**Edwin I. Hatch Nuclear Plant, Units 1 and 2
Request for Additional Information (RAI)
Fourth 10-Year Interval Inservice inspection Program**

Enclosure: Hatch Nuclear Plant – Units 1 and 2, Response to Request for Additional Information Regarding Proposed Relief Requests for the Fourth ISI Interval ISI-RR-04 and ISI-RR-10

ISI- RR-04, (HNP, Unit 2) ASME Code, Section XI, Examination Category B-J, Dissimilar Metal Pressure Retaining Welds in Piping NPS 4 or Larger Circumferential Weld

ISI- RR-10, (HNP, Unit 2) ASME Code, Section XI, Examination Category B-F, Pressure Retaining Dissimilar Metal Welds in Vessel Nozzle-to Safe End Welds NPS 4 or Larger

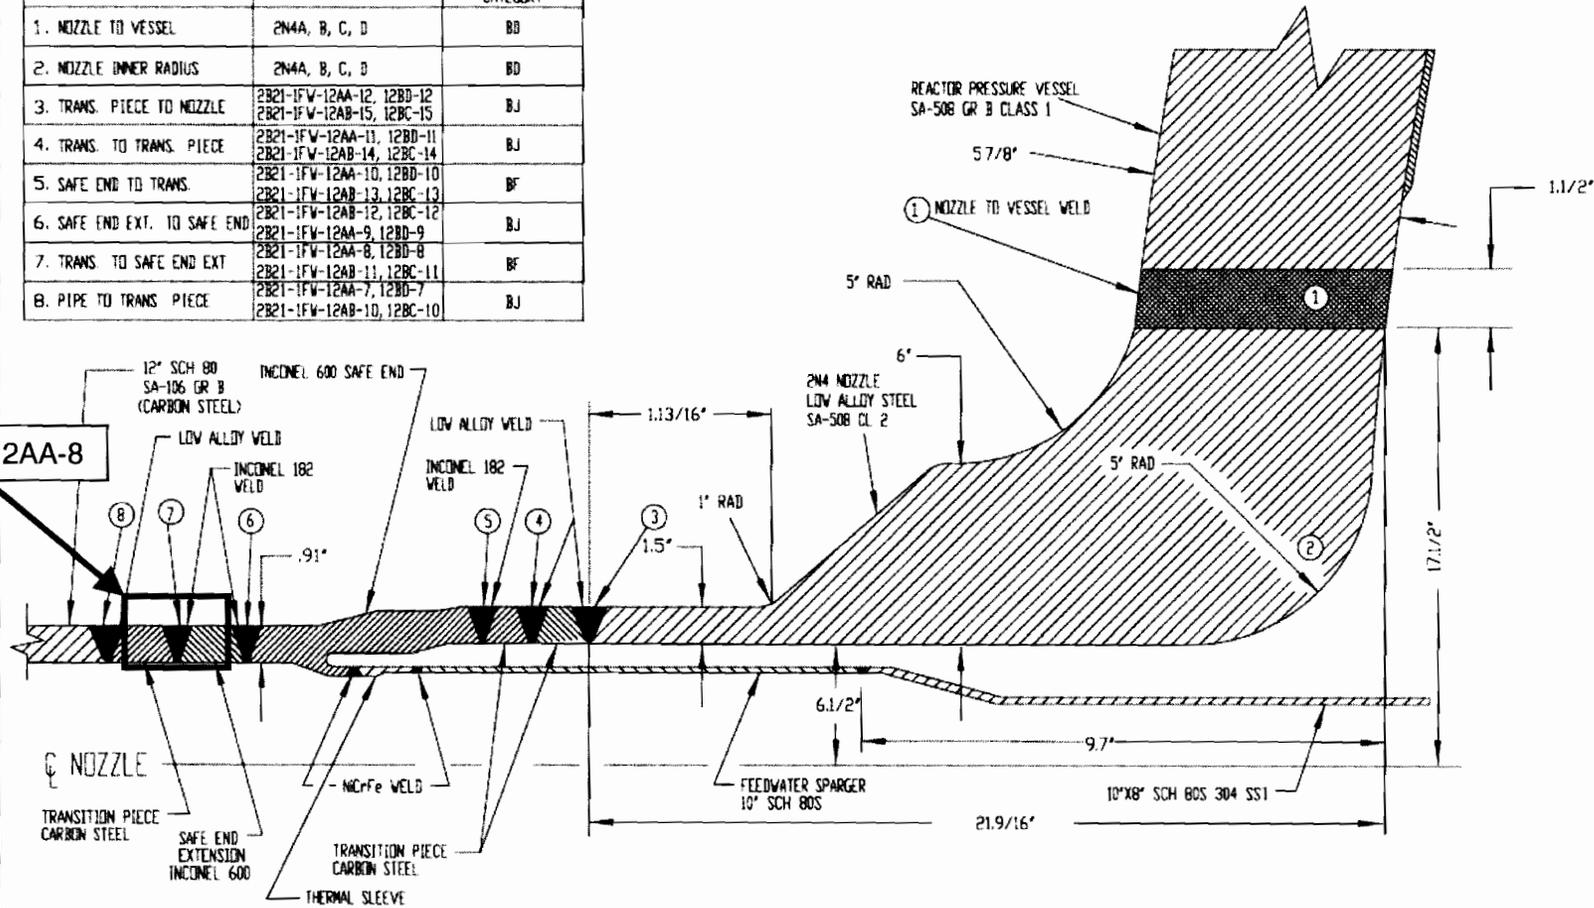
In the response to the NRC's Request for Additional Information, it was noted that two subsurface, circumferentially oriented, planar flaws were detected in Weld 2E21-1CS-10A-21 and one subsurface, circumferentially oriented, planar flaw was detected in weld 2E21-1CS-10B-20. Please describe how these flaws were determined to be subsurface. Is there a reinspection plan in place for these welds? Also, please explain how it is that weld shrinkage created the exact same examination limitation on two different welds.

1. SNC is aware of previous examination issues in the industry where only the upper portion of a flaw was detected during an examination and was evaluated as a subsurface flaw. Subsequently, after further weld preparation and re-examination, it was determined that the flaw was actually connected to the inside surface. This situation occurred at Hatch on a recirculation inlet nozzle-to-safe end weld during the same 2009 outage in which the subject Core Spray welds were examined. However, for the Core Spray welds, the automated phased-array display clearly showed that no flaws are closer than 1/4" to the inside surface. Prior to the Core Spray weld examinations, the weld crowns were removed and the only examination interference was from shrinkage at the downstream toe of the welds. A review of the data sheets indicates that there was no interference during the examination of the welds for circumferentially-oriented flaws; therefore, the circumferentially-oriented indications were determined to be subsurface.

2. These flaws were evaluated as subsurface and acceptable in size. Therefore, there are no plans to re-inspect these welds per IWB-2420(b).
3. These Core Spray welds are both safe end-to-nozzle welds (Train A and B) that have essentially the same configuration. Therefore, the weld shrinkage area causing the limitation was in the same location.
